DOMINION ENERGY KEWAUNEE, INC.
KEWAUNEE POWER STATION
RESPONSE TO REQUEST FOR ADDITIONAL INFORMATION REGARDING NRC
GENERIC LETTER 2008-01

RESPONSE TO REQUEST FOR ADDITIONAL INFORMATION
GENERIC LETTER 2008-01

DOMINION ENERGY KEWAUNEE, INC.
KEWAUNEE POWER STATION

Figure 1, Pulse Test 1/14/09, Known Void Total = 0.494 ft³

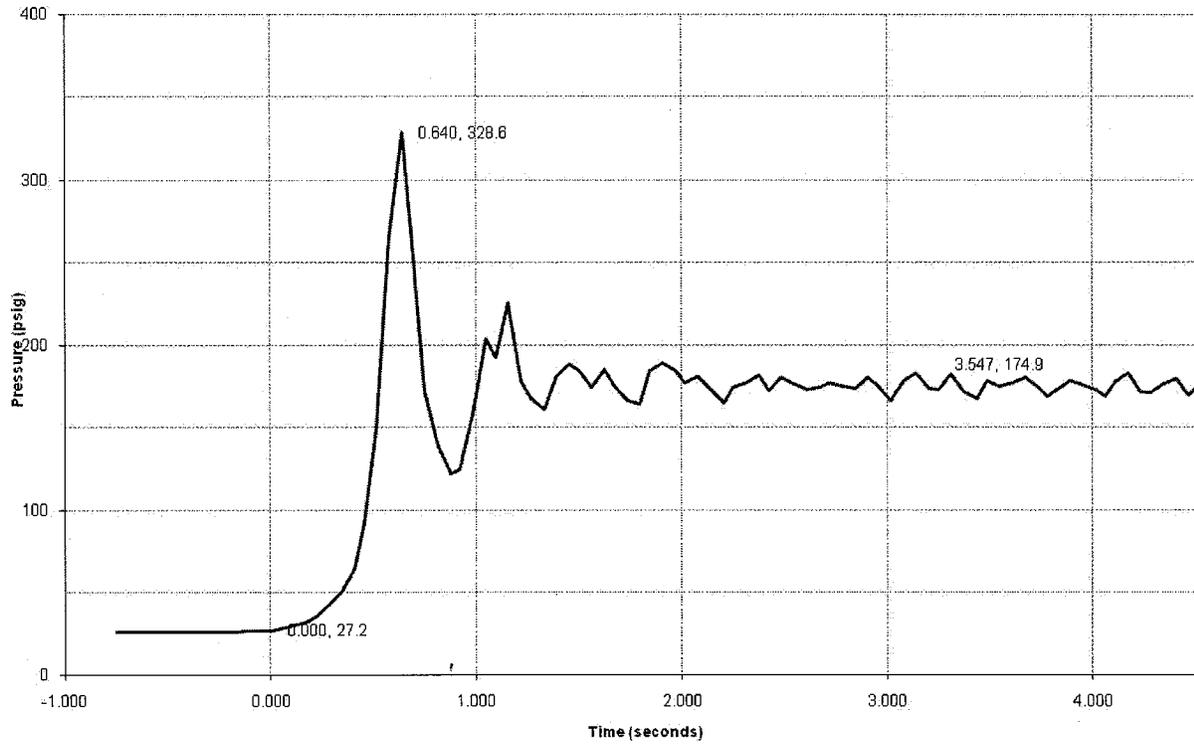
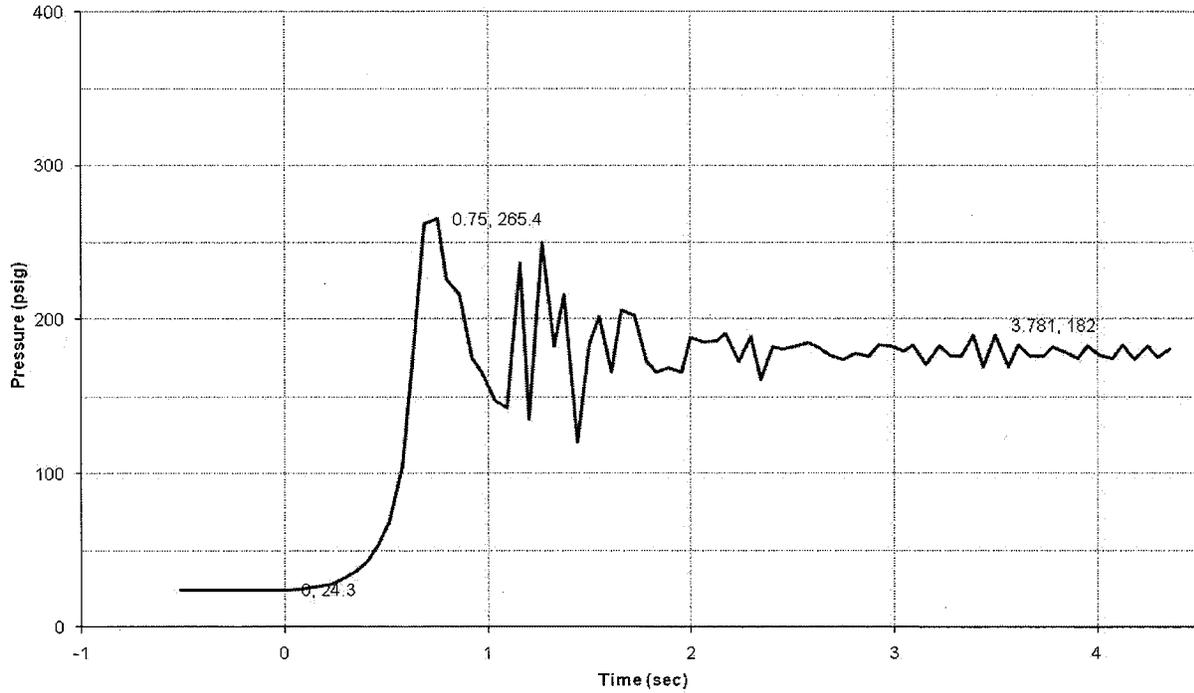
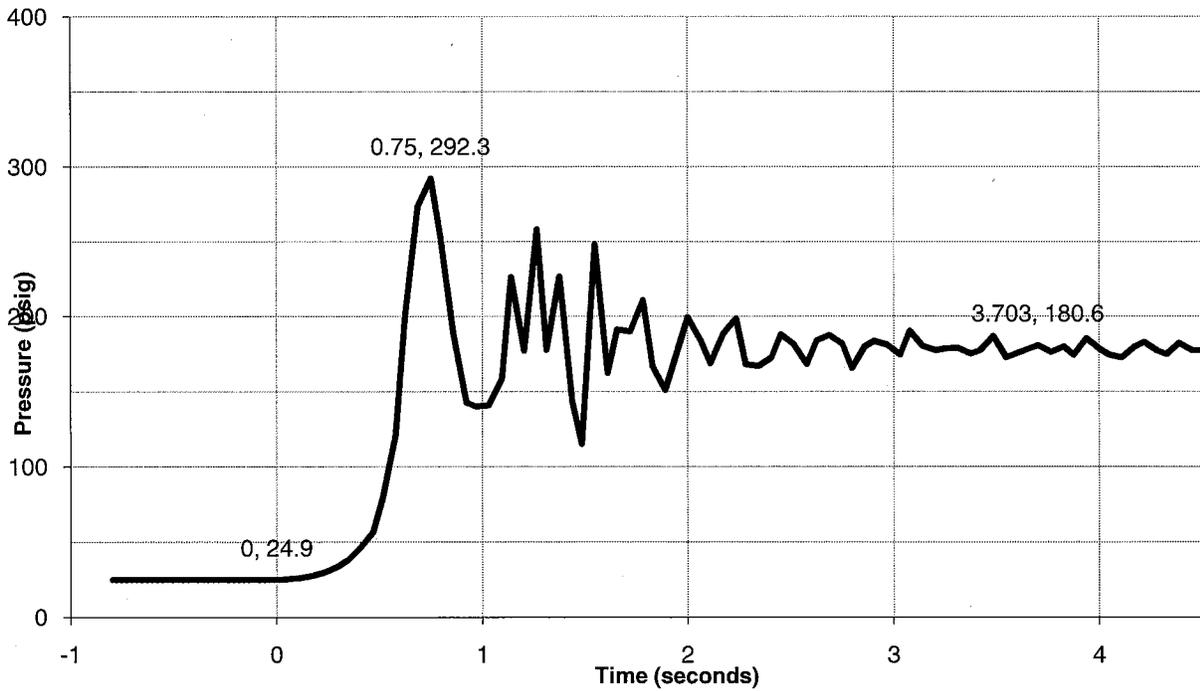
Please summarize the methodology and applicable limits for gas accumulation in the discharge piping of the low head safety injection (RHR) and ICS systems for Kewaunee. (Page 13)

Pressure pulse testing has been incorporated into the quarterly IST performed per SP-34-099A and B. The results of the tests performed for RHR Train A in January, April, and July 2009 are shown in Figures 1, 2, and 3 below.

The results of these pulse tests confirm that the peak pressures predicted by the Fauske method are extremely conservative. The Fauske method predicted a peak pressure of 560 psia (545 psig) with a 0.087 ft³ void in the mini-flow recirculation piping. During the pulse test on January 14, 2009, this size void was present, along with suspected voids of 0.098 ft³ in the letdown cross-connect line and 0.309 ft³ in the SFP cooling cross-connect line. The measured peak pressure was only 343.3 psia (328.6 psig). On April 8, 2009, the void in the mini-flow recirculation line had extended into the main RHR header with a size of 0.34 ft³. The voids in the letdown and SFP cooling lines were also assumed to still have been present, for a total void size of 0.747 ft³. The resulting measured peak pressure was 280.1 psia (265.4 psig). Note that the true peak pressure was not captured due to the sampling frequency of the instrumentation. However, the general characteristics of the pressure response were similar to the pulse test on January 14, 2009, giving confidence that the peak pressure was similar. Testing on July 10, 2009 produced results similar to the previous tests.
